Transport  
for NSW

# Sydney Harbour Bridge Cycleway - Northern Access Project Design Competition Jury Report

February 2022

Figure 03 Design entry images from Civile team

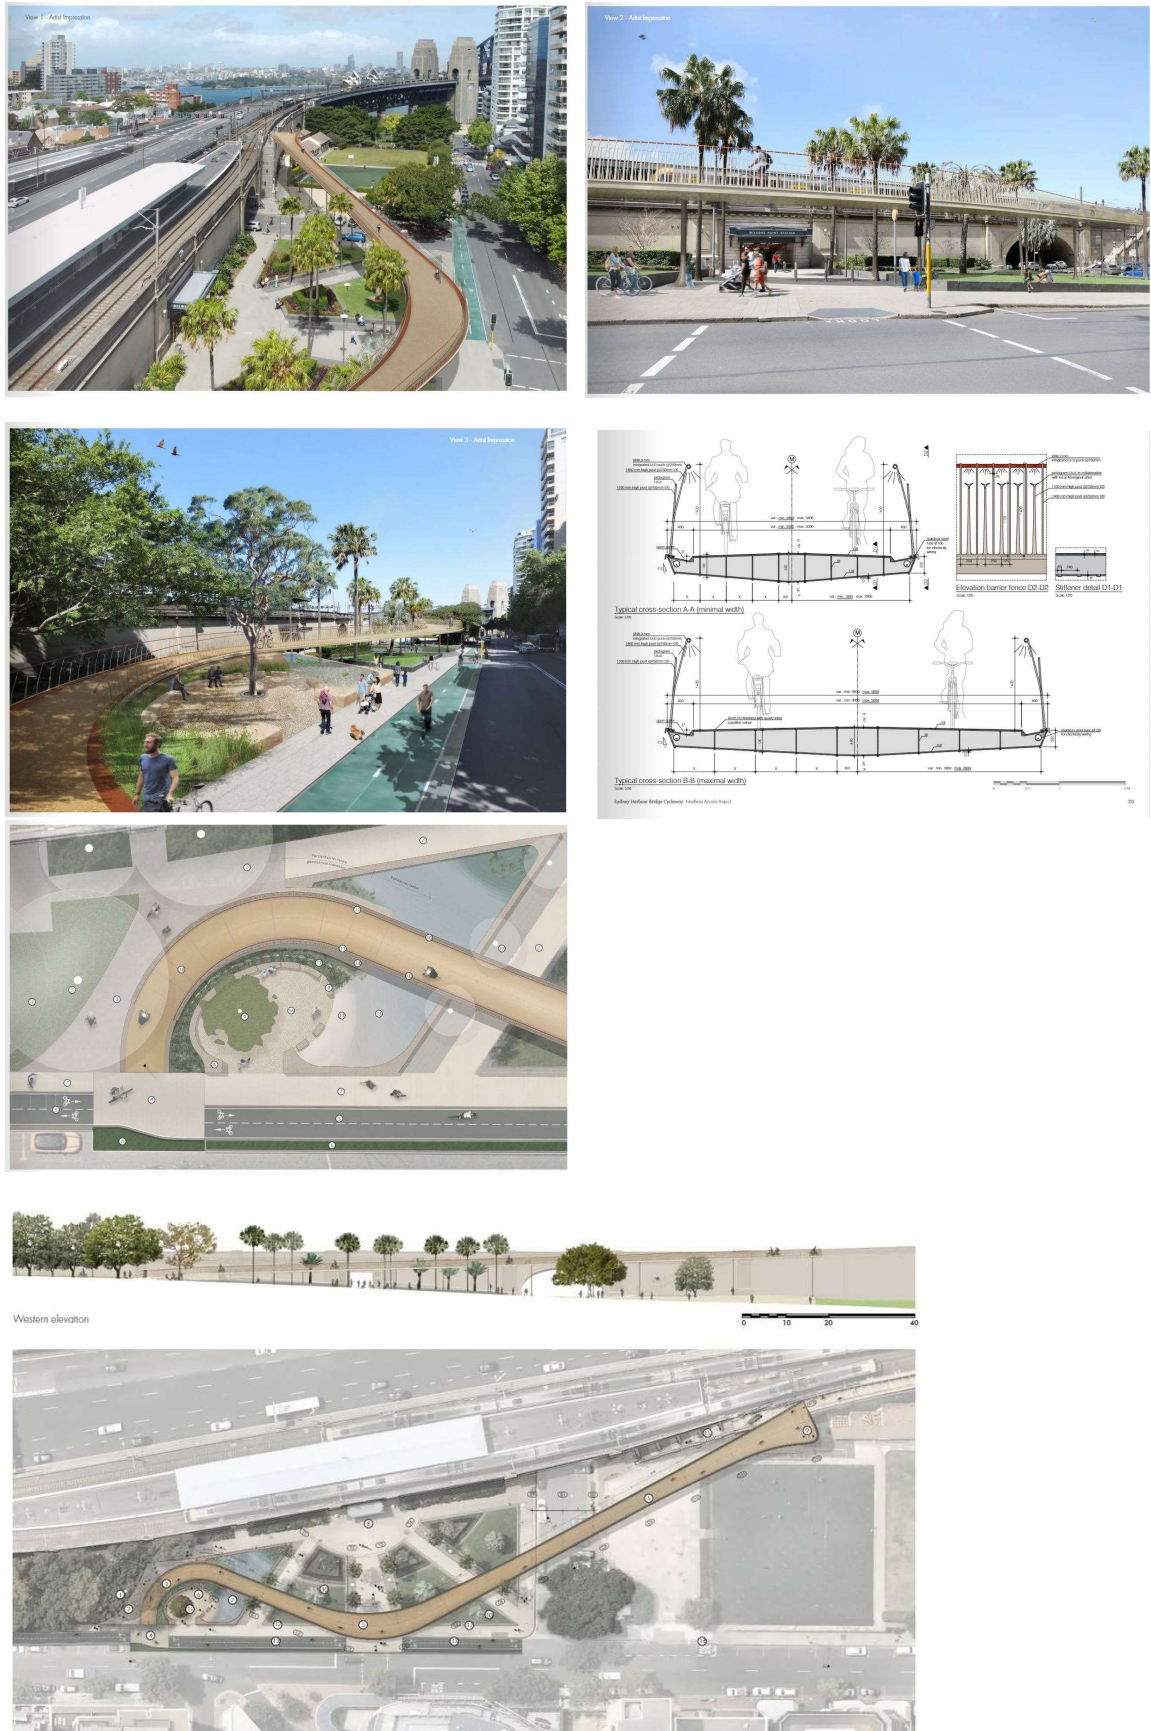
- A well resolved and confident design with a dynamic form that sweeps away from the Bridge viaduct and into Bradfield Park Plaza.
- Having a thorough appreciation of the cycling and pedestrian movements in the precinct, which informed the alignment of the ramp, junction with the existing Sydney Harbour Bridge cycle path and the landing arrangement at the Alfred Street footpath.

- Offering a new meeting place through the provision of seating at the ramp landing in Bradfield Park plaza with minimal impact to existing trees, with the exception of an historic Jelly Palm, which could likely be transplanted. Note: this Jelly palm is separate to the Jelly Palm in the plaza lawn terrace that has recently died.

- Further extending the Reference Scheme heritage strategy of staying clear of the Bridge viaduct wall structure and Railway Station entry, developing a sweeping curve with an alignment that echoes the radial plaza layout whilst ensuring that the ramp is read as an element separate from the Bridge.

- Providing a refined structure and balustrade detailing
- Minimising the visual impact of the ramp structure on the viaduct wall and station entry once inside the 'sweep' of the ramp's curve

- Minimising the impact on Bradfield Park North whilst maintaining the pleasant and well-used pedestrian pathway and view along the curved northern viaduct approach wall, through the ramp's alignment in the plaza and the position of the landing.

- Including several designing with Country themes that would add to the user experience and understanding of place. In particular, the proposals at the ramp landing that integrate water, sandstone and landscape. Integration of water also provides a visible expression of water sensitive urban design.

- One interpretation of this ramp alignment approach (of minimising visual impact of the viaduct wall and station entry from 'inside' the ramp) is that the ramp frames the public open space, enabling the plaza to 'belong' to the Station entry and protecting it from the street. Another interpretation of this outcome is the ramp interrupts State-listed significant views to the curved northern approach of the Bridge (SHR00781) and diminishes the spatial integrity and open sky experience of the plaza, visually cutting it off from the street. It is noted that the Bradfield Park setting has "Exceptional" heritage grading (per the SHB Conservation Management Plan) and includes Milsons Point Station, entrance, canopies and plaza area and Bradfield Park North.

- Encroaching over the Alfred Street footpath, affecting State-listed significant view to the Harbour Bridge particularly from a southern approach on Alfred Street. A narrowing of the wide ramp deck could reduce this impact.

- Affecting heritage significant views of the plaza, Bridge wall, the date and cartouche above the Station canopy and Station from Alfred Street, when outside the 'sweep' of the ramp's curve.

- Requiring further design development to ensure that the slender ramp structure, slender columns and crafted balustrade are achievable. Despite assurances of previous European precedents, the Jury considered the design would need to address structural and vibration requirements to develop column sizing and connection details, consider footing constraints that may affect column spacing and further develop soffit details/materials/finishes.

- Requiring further review of the generous ramp width. Whilst acknowledging the benefit of having extra cycling space on curves and on steeper gradients, the ramp widening up to approximately 5.8m at Alfred Street at a relatively low height could be overbearing for pedestrians and impact views down Alfred Street toward the Bridge pylons and arch.

- Requiring further review of the ramp height over the northern diagonal pedestrian path, which at approximately 2.4m to the underside of the ramp is not a height suitable in a public space and could feel overbearing. The ramp could be increased in height at this location through steepening the ramp gradient. It is acknowledged that a steeper gradient could have implications on reducing the ramp width as suggested in the preceding point.

- Investigate the ramp alignment both in the plaza and at the ramp landing to minimise impacts to existing trees including the historic Jelly Palm and the mature Chinese Elm which has a raised rootzone in the landing area.

Figure 04 Design entry images from ASPECT Studios

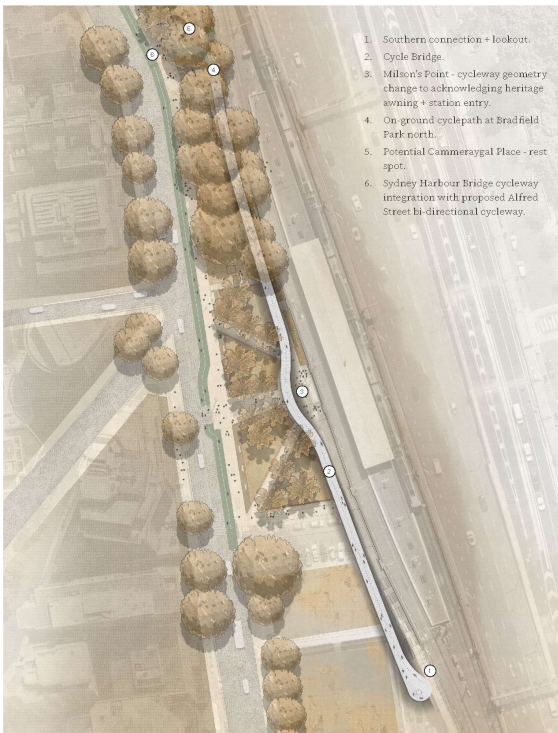
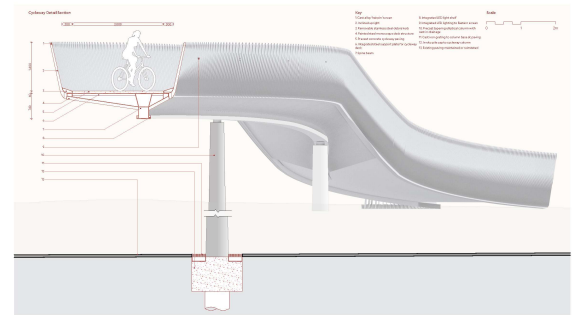
- An elegant and streamlined design that prioritises the open space setting of Bradfield Park plaza, consistent with the Design Principles defined in the Services Brief.

- Providing a relationship between the historic Bridge and new transport infrastructure through aligning with the approach curve of the viaduct and offsetting at the Railway station entry portico.

- Retaining legibility and sightlines to the Railway Station entry portico from different viewpoints through the soft curved alignment with the radial plaza layout and height of the ramp. Whilst clearly an intervention, the existing uses of the Bradfield Station plaza mostly remain intact.

- Offering a gentle cycle grade and a clear and direct route for the majority of cyclists moving through the precinct to or from the north.
- Locating the landing point of the ramp further north, where the pedestrian traffic is not as heavy as it is further south around the plaza and pedestrian crossing.

- Minimising impact to existing trees, paths and gardens within Bradfield Park plaza and minimising the visual impact of the ramp structure on views along Alfred Street toward Harbour Bridge through the ramp's alignment with the viaduct

- Creating a sophisticated design response through the thoughtful detailing of the structure and balustrade.
- Providing a not overtly literal response to designing with Country themes, primarily the whale inspiration for the balustrade concept.

- One interpretation of this ramp alignment approach (of minimising impact on Bradfield plaza and the Alfred Street views) is that the plaza, and in particular the landscaped terraces, is able to be a predominantly uninterrupted landscaped space that is open to the sky and a clear part of the public realm of the street, with views retained to the Harbour Bridge arch from Alfred Street footpath. Another interpretation of this outcome is the ramp impacts the reading and full appreciation of the viaduct wall and the station entry and interrupts the significant view along the northern approach as seen in Bradfield Park North. The aesthetic significance of the curved northern approach with continually changing views of the Bridge and harbour is identified in the statement of significance as part of the State heritage listing of the Sydney Harbour Bridge, approaches and viaducts (road and rail) SHR00781. It is noted that the Bradfield Park setting has "Exceptional" heritage grading (per the SHB Conservation Management Plan) and includes Milsons Point Station, entrance, canopies and plaza area and Bradfield Park North.

- Having a long extension and therefore encroachment into Bradfield Park north due to the gentle ramp gradient. Further review is required which could consider steepening the ramp once beyond the plaza to minimize this encroachment.

- Impacting the continuity of the State-listed heritage significant view along the viaduct approach wall, when approaching through Bradfield Park North, and obscuring part of the design detailing at the top of the approach wall and the date and cartouche above the station canopy.

- Creating two potential points of pedestrian/cyclist conflict – one in Bradfield Park North and one at the footpath on Alfred Street (as opposed to just Alfred Street). Further review is required to resolve the interface with the pedestrian park within the path, and enable its continuity.

- Removing a significant portion of the well-used pedestrian pathway that runs along the viaduct wall in Bradfield Park north, requiring pedestrians to divert and join the footpath on Alfred Street. A closer or further offset alignment to the viaduct wall could enable this path to be reshaped or maintained. It is acknowledged that a closer alignment may create a requirement for review of throw screens on the ramp or potentially atop of the wall, in addition to removal of a number of Poplar trees. (It is noted that these trees are not significant and provide current technical challenges due to their proximity to the rail corridor.)

- Requiring refinements to the balustrade such as the cycling bump rail, or consideration of a vertical rather than angled alignment. Future design development could also consider a recessed structural beam.

- Requiring more meaningful Designing with Country expression to ground the design in 'belonging' to the park and the Bridge.
